# HISTORIC AND DESIGN REVIEW COMMISSION

September 20, 2017

**HDRC CASE NO:** 2017-450  
**ADDRESS:** 2059 W WOODLAWN  
**LEGAL DESCRIPTION:** NCB 1963 BLK 1 LOT W 49.2 FT OF 15  
**ZONING:** R-6 H  
**CITY COUNCIL DIST.:** 7  
**DISTRICT:** Monticello Park Historic District  
**APPLICANT:** Zamaira Velazquez  
**OWNER:** Zamaira Velazquez  
**TYPE OF WORK:** Stucco replacement, window replacement, enclosure of side porch  
**REQUEST:**

EXISTING FLOOR PLAN, ARCHITECTURAL FLOOR PLAN.  
2059 W Woodlawn Ave.

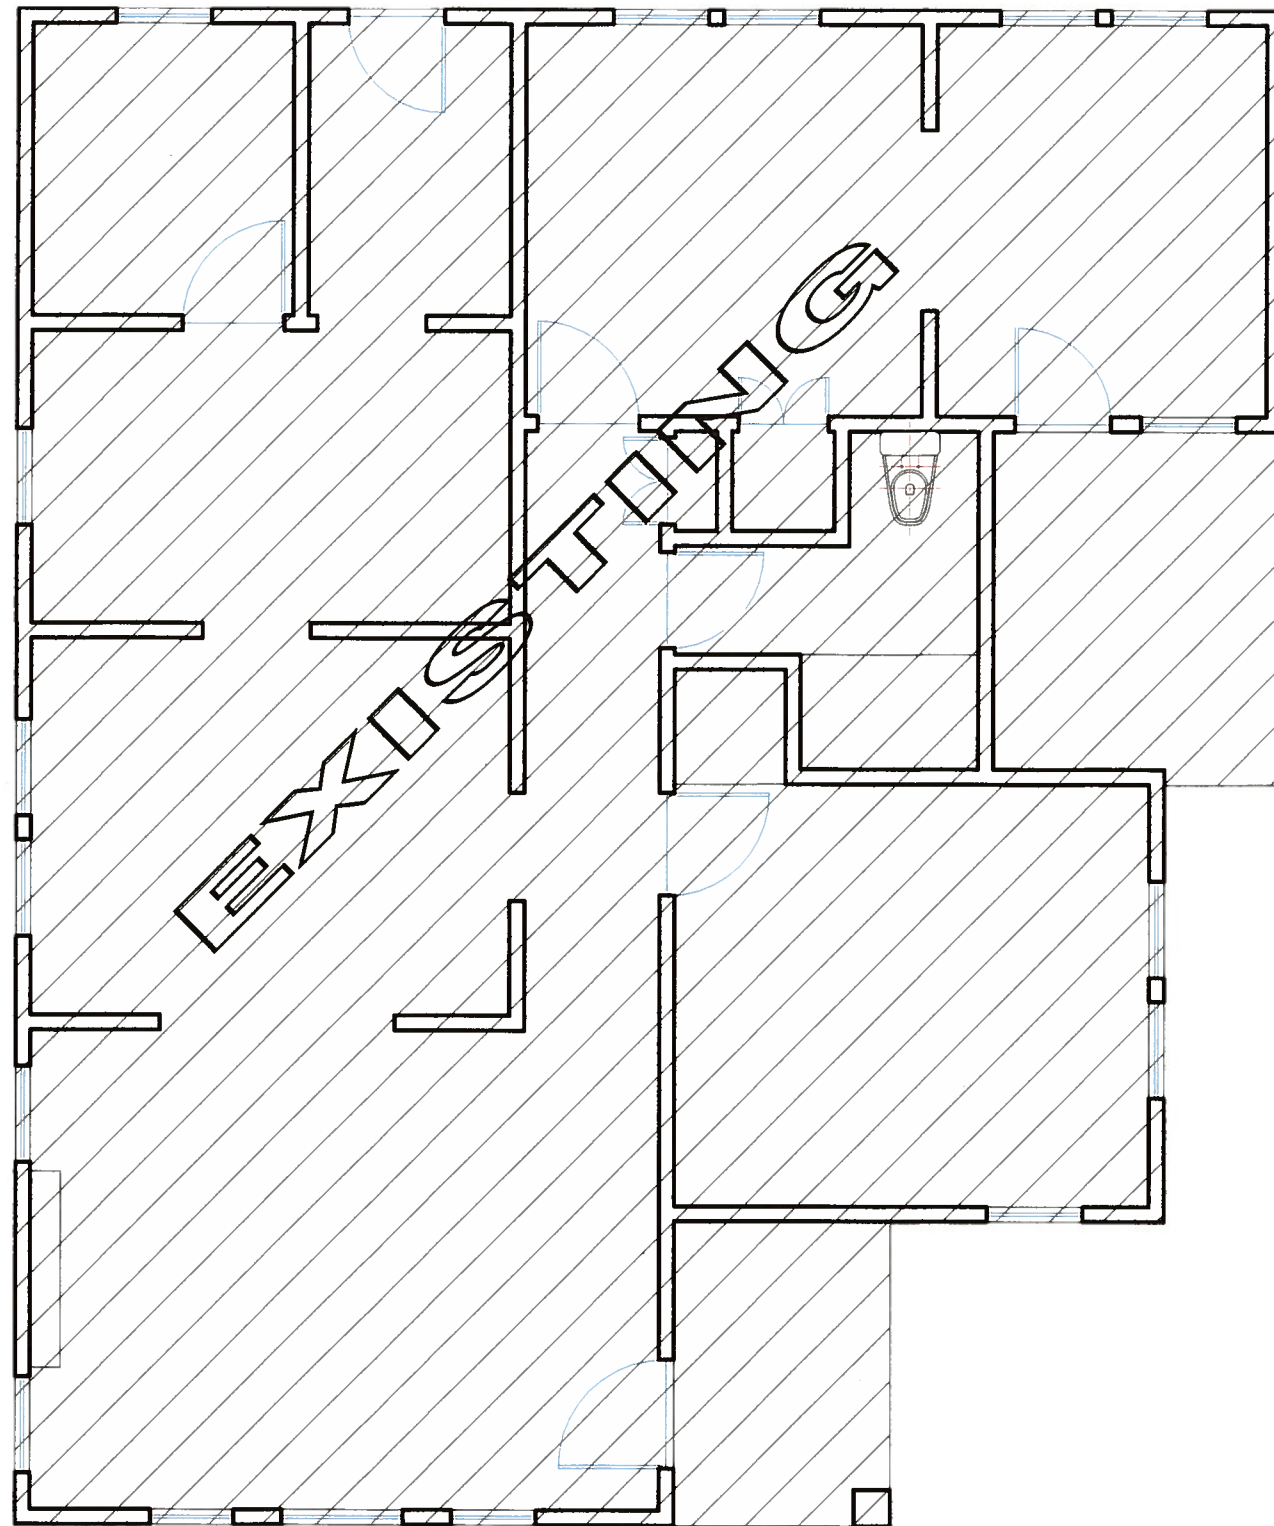
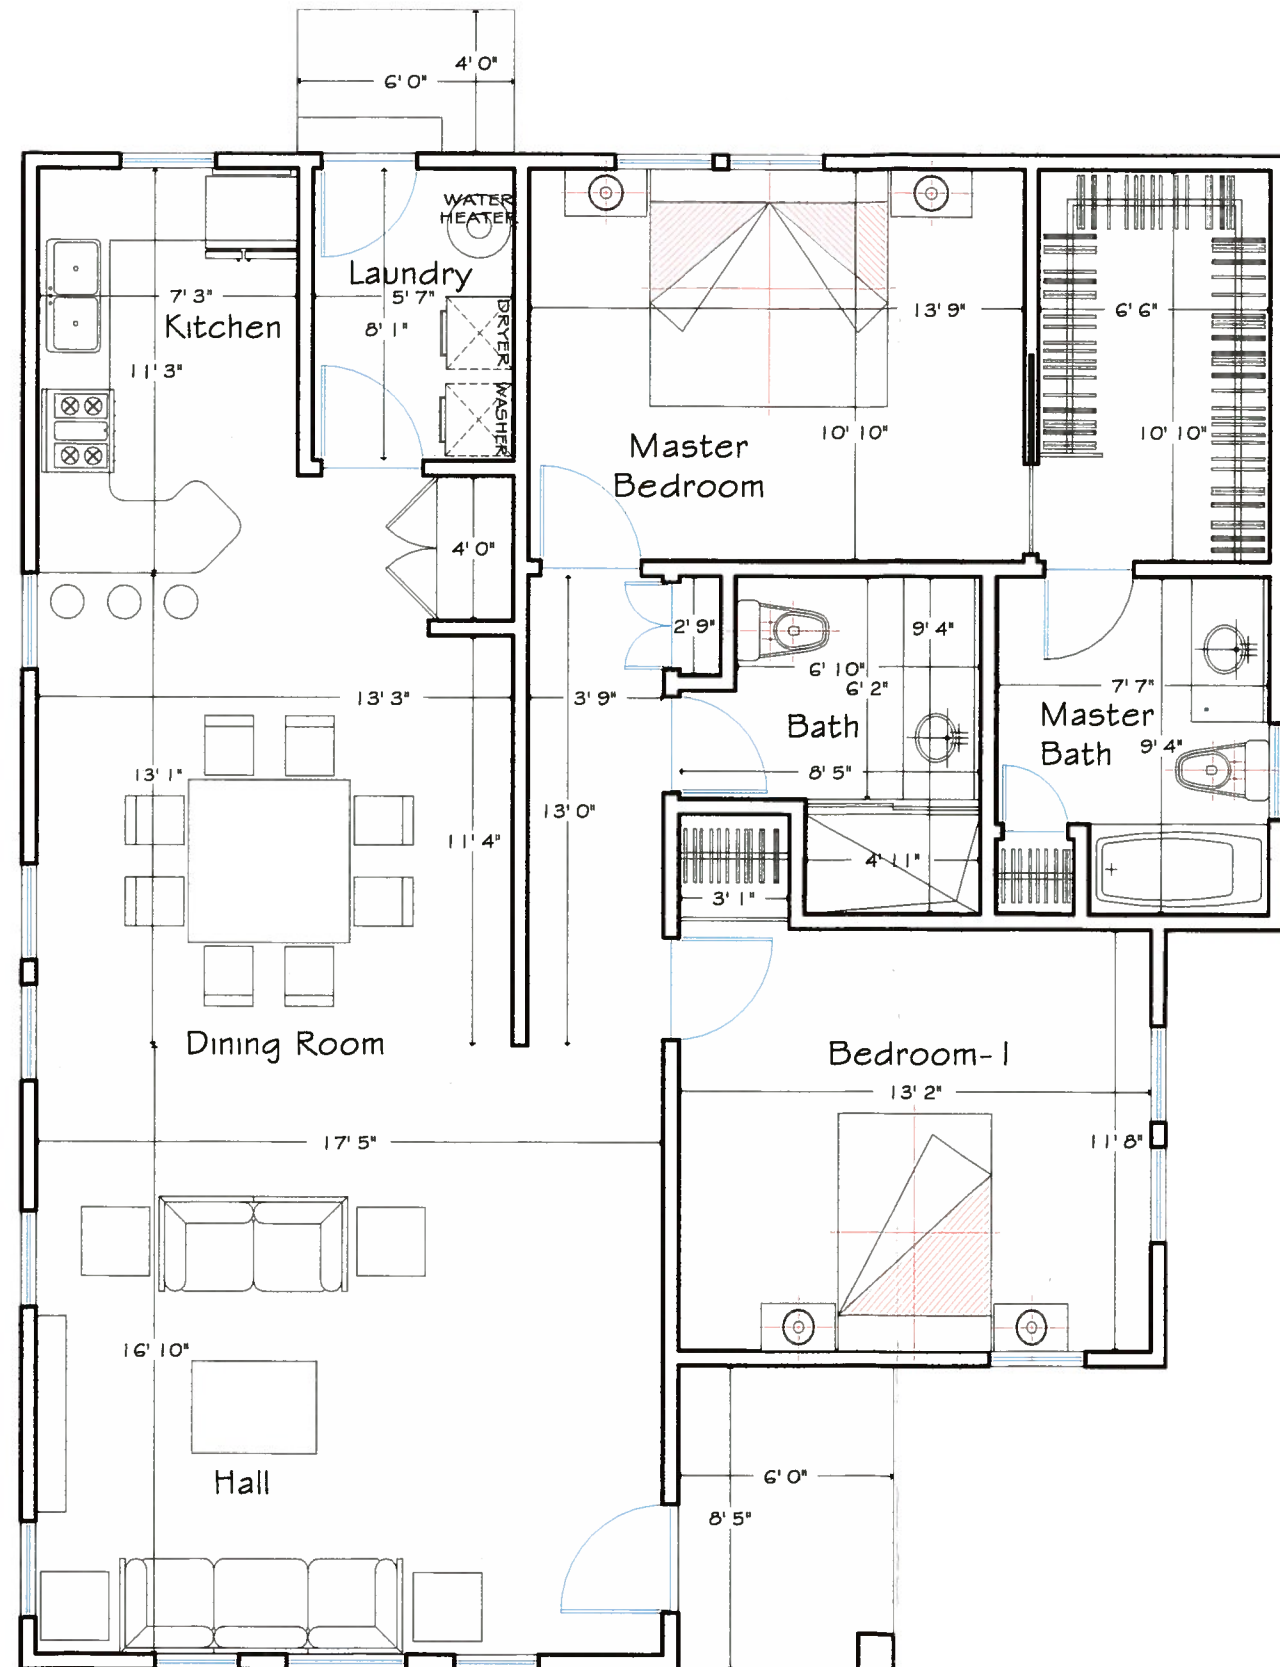
- d. **PORCH ENCLOSURE** – The applicant has proposed to enclose an existing side porch to create additional conditioned space. The Historic Design Guidelines encourage retaining existing porches; however, the existing porch on this home is not architecturally or historically significant. The proposal will not obscure any character-defining features. Staff finds the proposal consistent with the Guidelines.

Item 3, Staff recommends approval of the rear porch enclosure based on finding d.
